Request for Proposal (RFP)  
 Bid No: Bid 26-05-4136SB  
 Addendum No. 3

**Date:** June 19, 2026  
**To:** All Proposers  
**Subject:** Addendum No. 3  
 Consisting of Seventeen (17) Pages  
**RFP No.:** Bid 26-05-4136SB  
**Project Name:** N9073(1)1,2&4 Blue Canyon Road Project in Apache County, AZ  
**Owner:** Navajo Division of Transportation

## Addendum No. 3

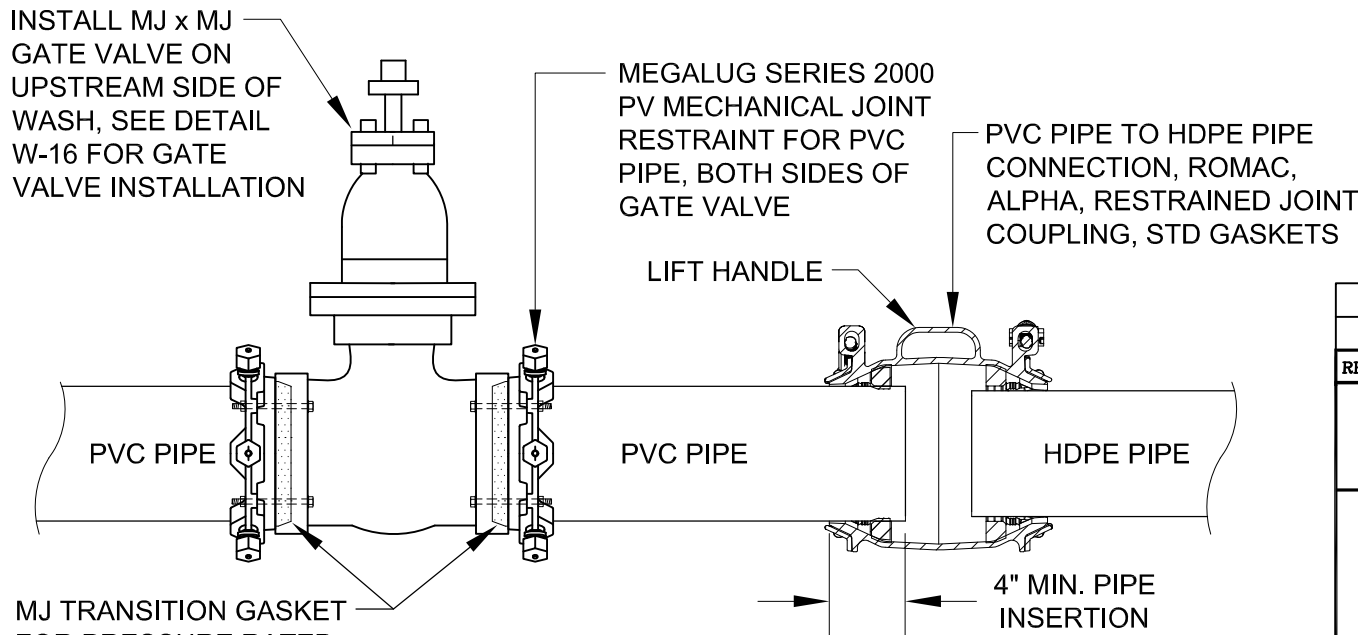
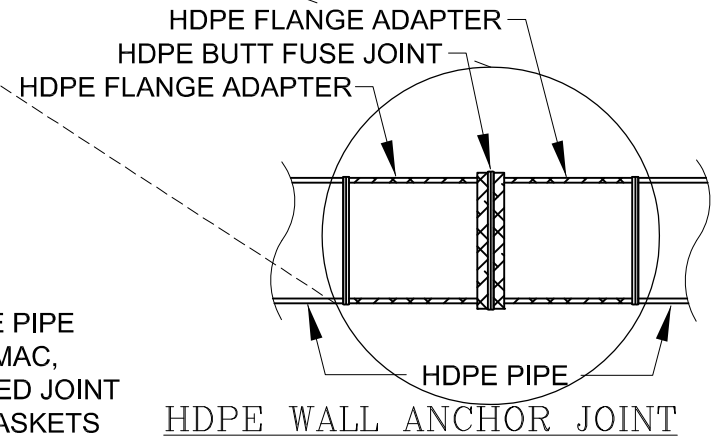
In the previous Addendum 2, a question was submitted about which was the correct pipe to use, PVC or HDPE. The reply was that BOTH PVC and HDPE pipes were to be used. To clarify the response, the NTUA Standard Detail W-33A HDPE Wash Crossing Detail was provided, which was to show the use of the PVC and HDPE pipes in a drawing. However, the standard detail provided in Addendum 2 was incorrect, because it was for pipes 14-inches and larger. Thus, the correct wash crossing standard detail is attached to this Addendum 3, NTUA Standard Detail W-33 HDPE Wash Crossing Detail for 4-inch Thru 12-inch pipe (See Addendum 2 for question and answers).

ESTIMATED QUANTITIES TABLES

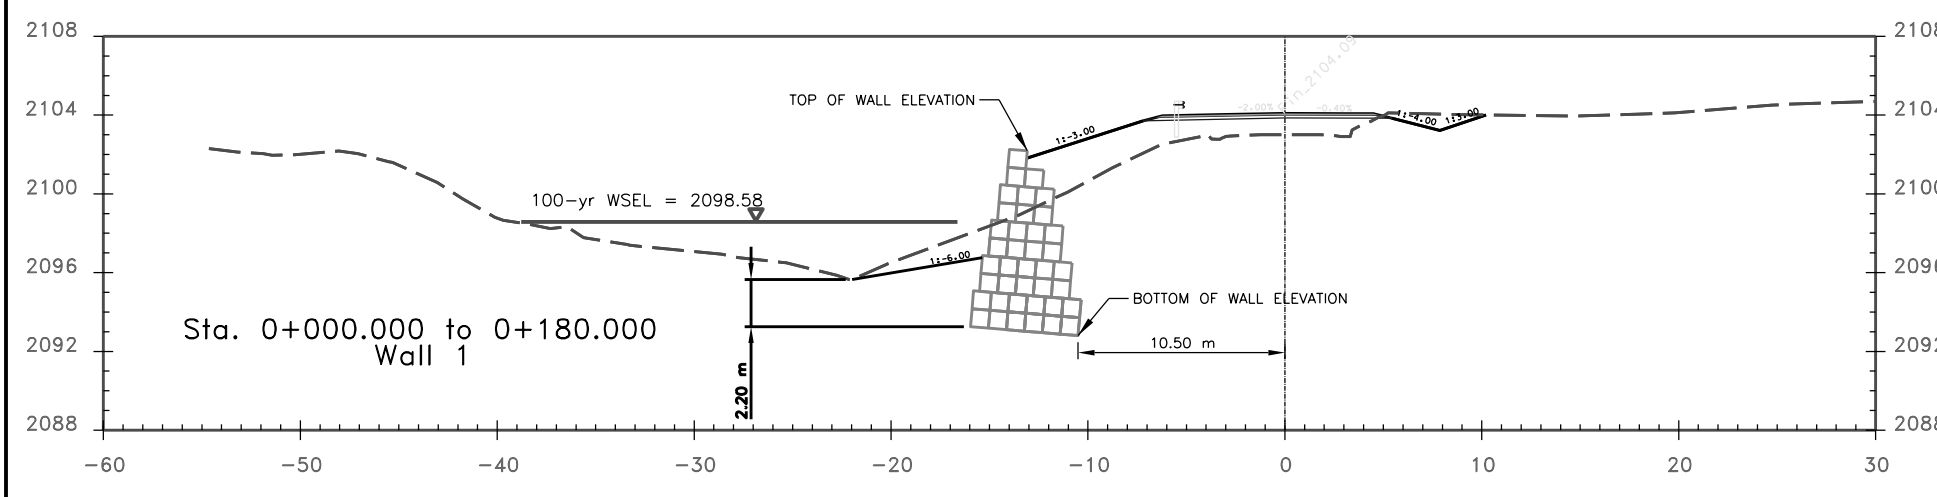
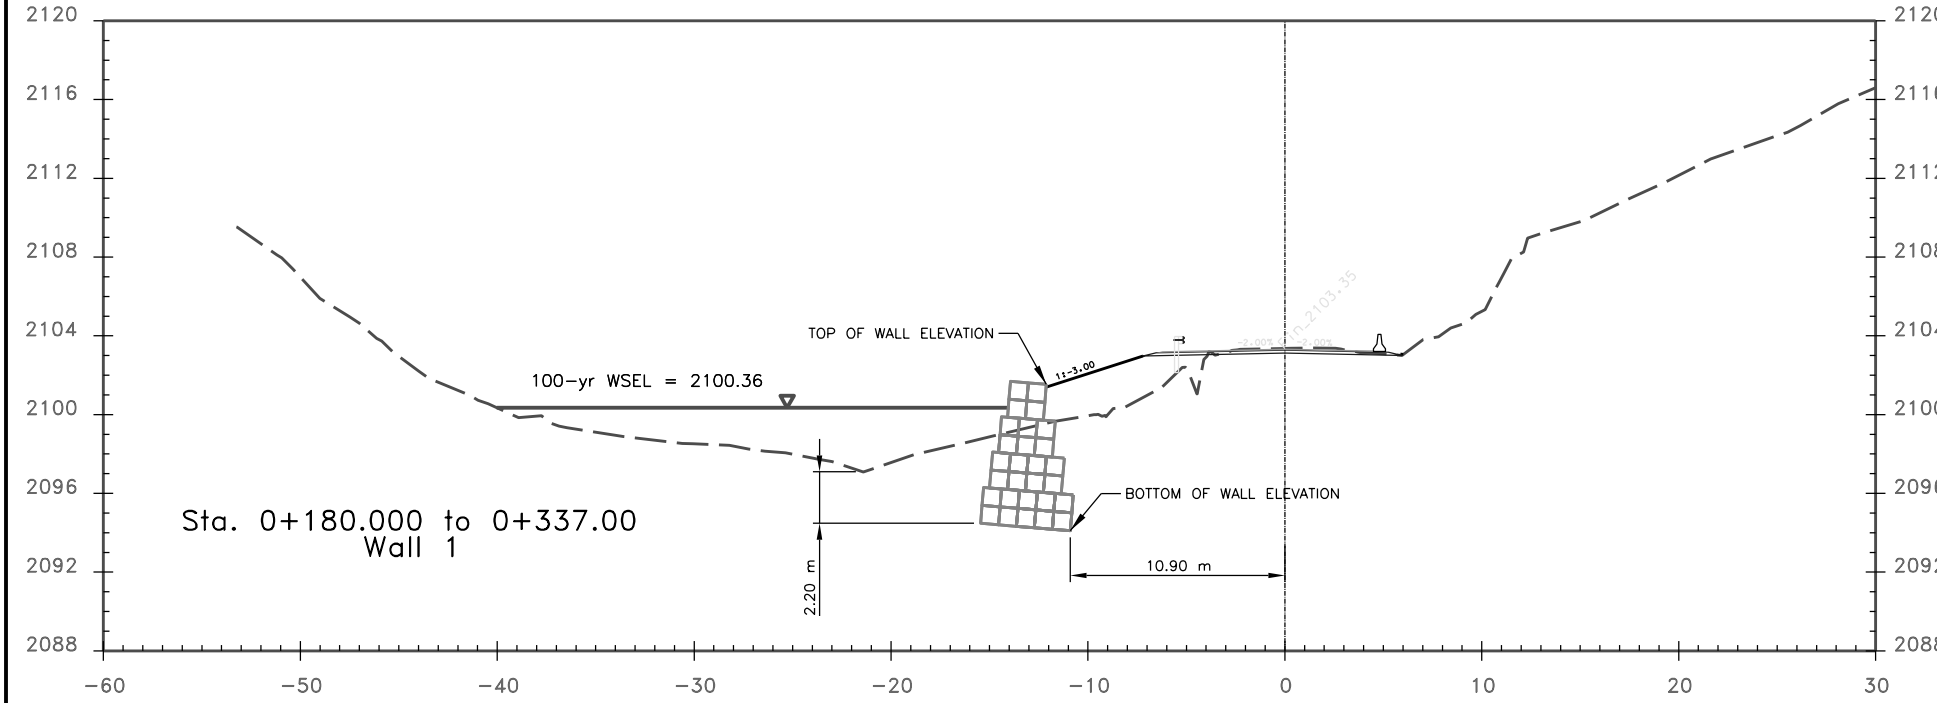
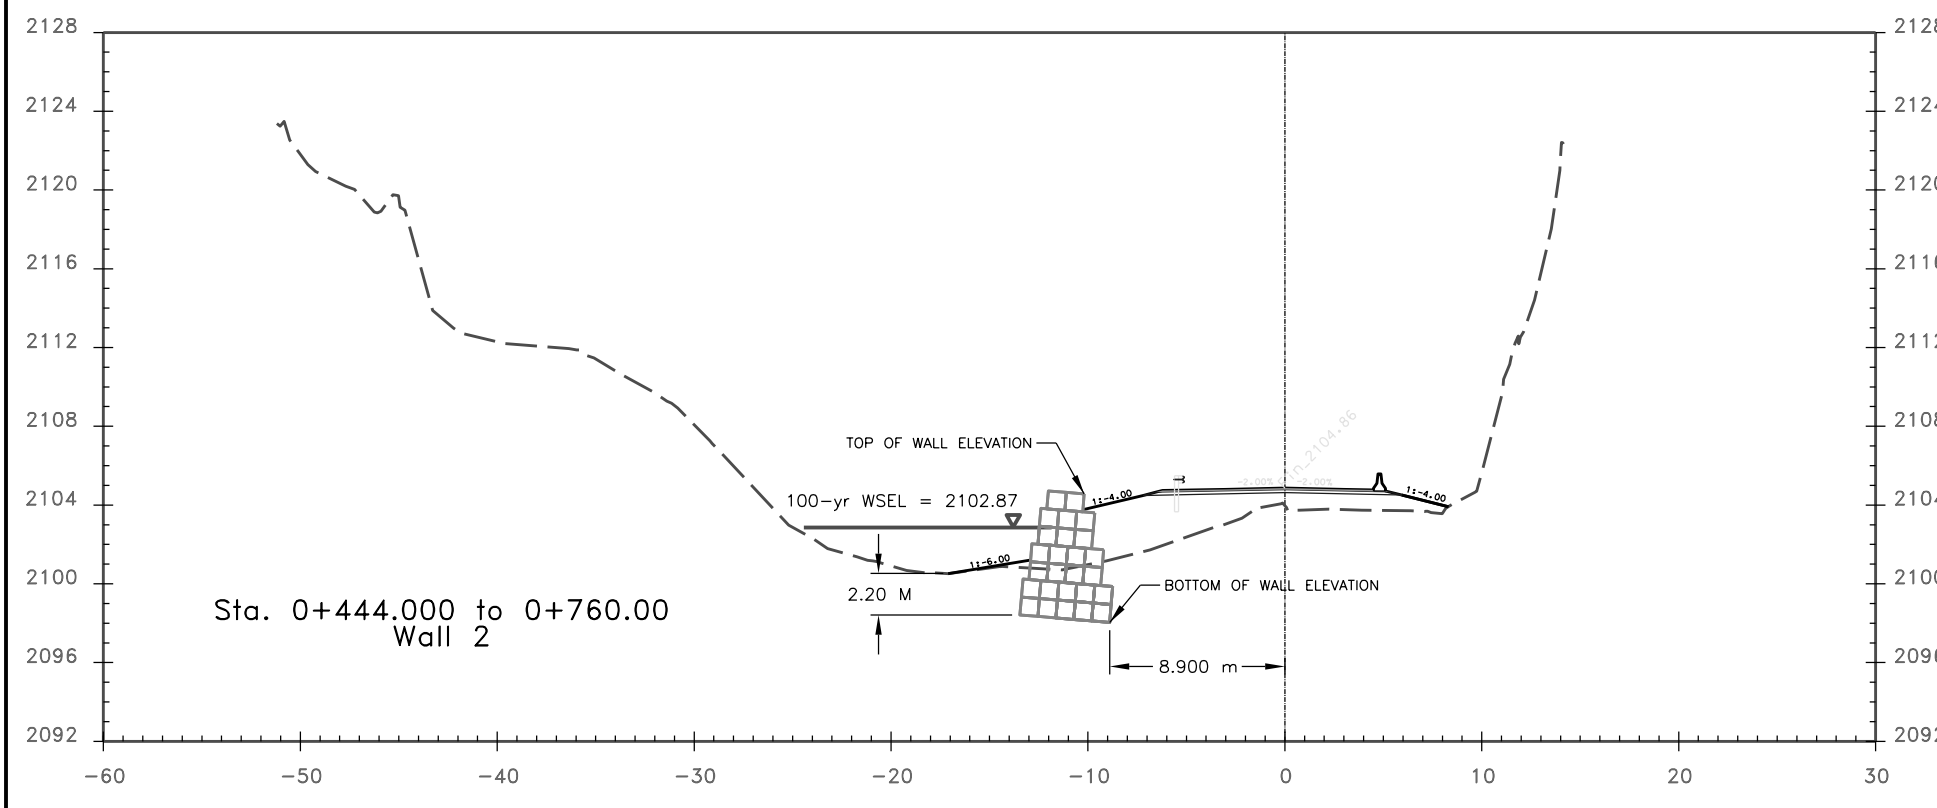
- The overall plans are being reviewed, and design revisions to the earthwork are being implemented. These implementations will be in a forthcoming addendum #4.
- Sheet 7 ESTIMATED QUANTITIES TABLES:
  - Revised to update the quantity for Bid Item No. 25302-100 Gabions, Aluminized Coated, Class 2 to 9,335 m<sup>3</sup>.
  - Revised for the updated NTUA waterline relocation design.
- Sheet 33A: Revised to update the quantity for Bid Item No. 25302-100 Gabions, Aluminized Coated, Class 2 to 9,335 m<sup>3</sup>, removing segment 2.
- Sheets 77-80: Revised for the updated NTUA waterline relocation design.
